PROJECT NUMBER 472-84901

PAVING IMPROVEMENTS
Mascot
WICHITA, KANSAS

SHEET 11 of 30

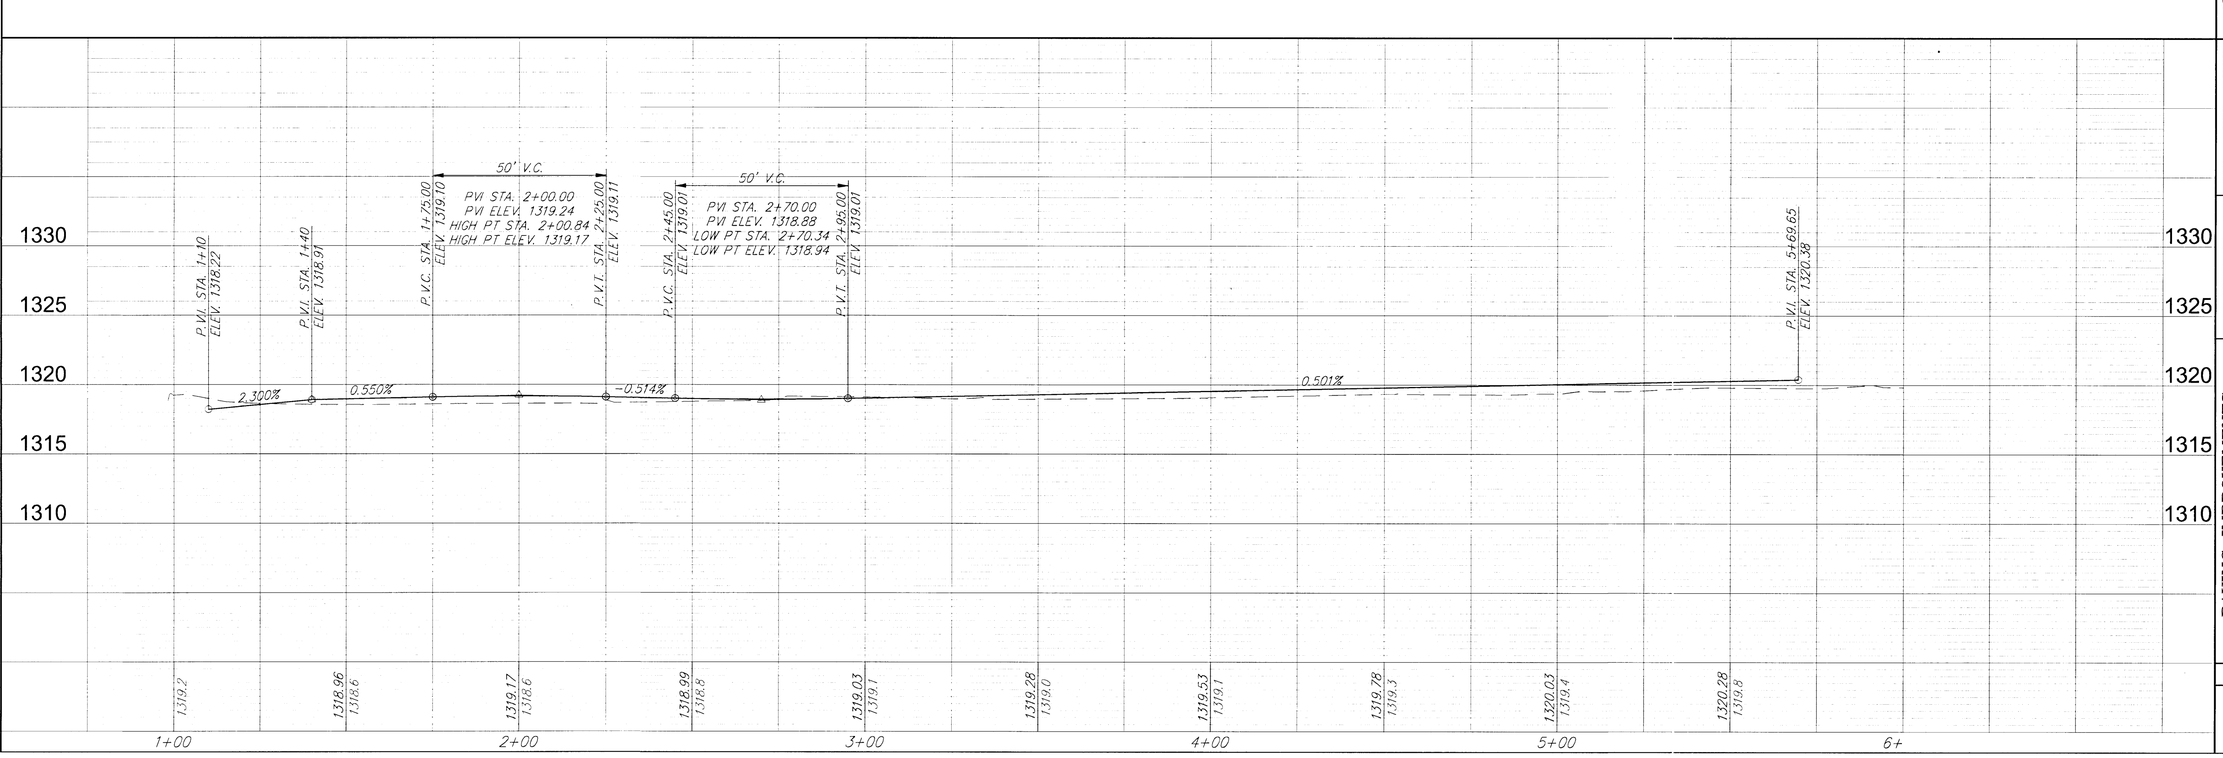
MASCOT STA 3+81.20
CONSTRUCT STANDARD DRIVE
(W = ~~12.0'~~) 25.0'

MOVE THIS DRIVE 2.0' TO THE NORTH TO COMPLY WITH 6.0' PROPERTY LINE SETBACK.

MOVE 2.0' N
